**City of Richmond**  
Urban Development Division

**Report to  
Development Permit Panel**

**To:** Development Permit Panel  
**From:** Holger Burke  
Acting Manager, Development Applications  
**Date:** February 3, 2004  
**File:** DP 03-239178  
**Re:** **Application by Bob Snowball for a Development Permit at 12060, 12080, 12086  
and 12100 7<sup>th</sup> Avenue**

LANDSCAPE PLAN

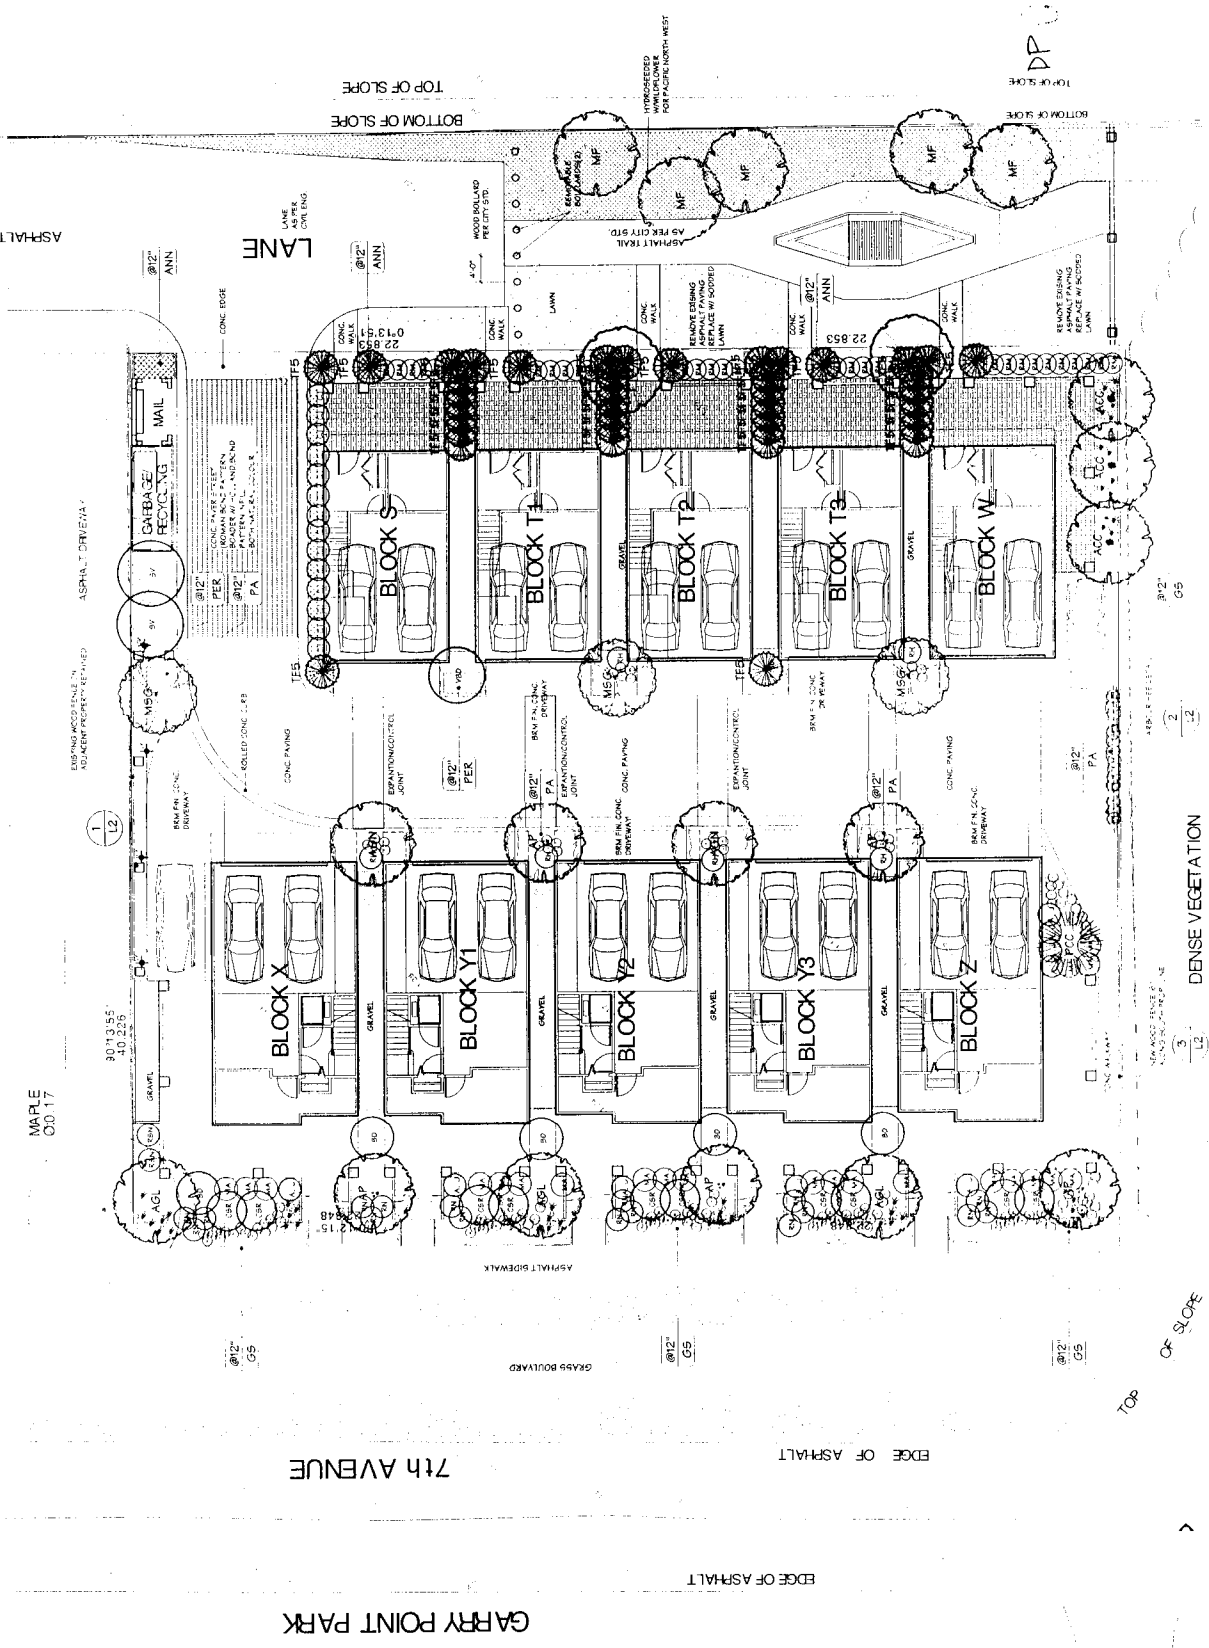
- A nice project – good treatments. The use of gravel between the buildings was questioned and groundcover was suggested as a alternative.
- Cst. Powroznik distributed written comments, a copy of which is attached as Schedule 5 and forms a part of these Minutes. The mail area should not be on the back lane. This area is too isolated and it will be vulnerable to break in and thefts. Wherever the mail area is located, it should not be enclosed on three sides. It should be open to the street or pedestrians walking by. There is a makeshift, unplanned path on the north-west corner of the property. It appears that the residents on the property to the north use this path. Perhaps the planned walkway could be moved to the north side and make it accessible for the residents of the neighbouring property as well. Ensure that there is lighting in the walkway to the east of the development.

- A great project.
- The previous comments were agreed to. The calliper sizes of the proposed trees was questioned.
- The provision of space for future elevator shafts was complimented. The applicant was also credited for the layout of the master bedroom en-suite – it was requested that backing board be provided alongside the commode.

SOUTH PROPERTY SECTION & BLOCK U  
SCALE 1/8" = 1'-0"

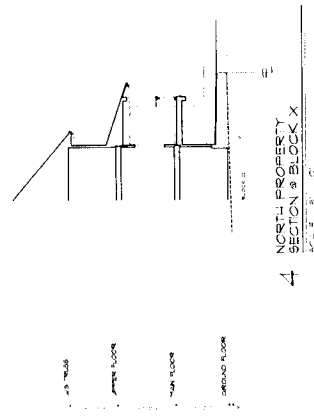
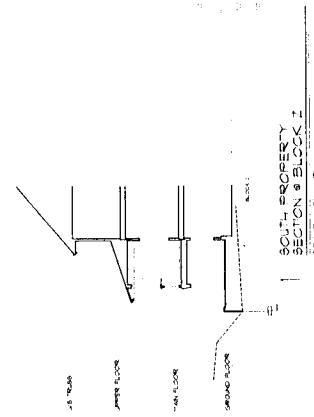
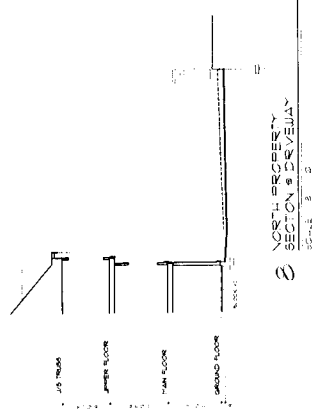
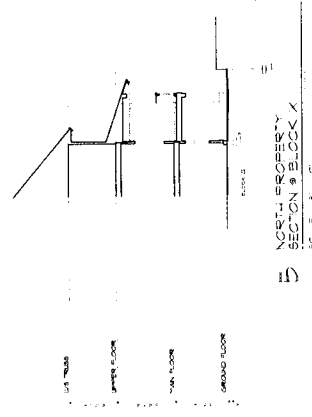
1. Conditions of Adjacency along the north and south property lines with differences in grade. ***There is an arbour, wooden fence and minor amount of retaining wall along the edge of the path adjacent to the south property line as detailed in the drawings.***
2. Site Planning and Urban Design: There is an uncomfortable relationship between the public realm on the sidewalk and the front yard/porches of the detached dwellings along 7<sup>th</sup> Avenue. ***As required by Engineering Department, the location of the 7th Avenue sidewalk provides a grass boulevard. The applicant has addressed this relationship through landscape screening and changes in grade.***
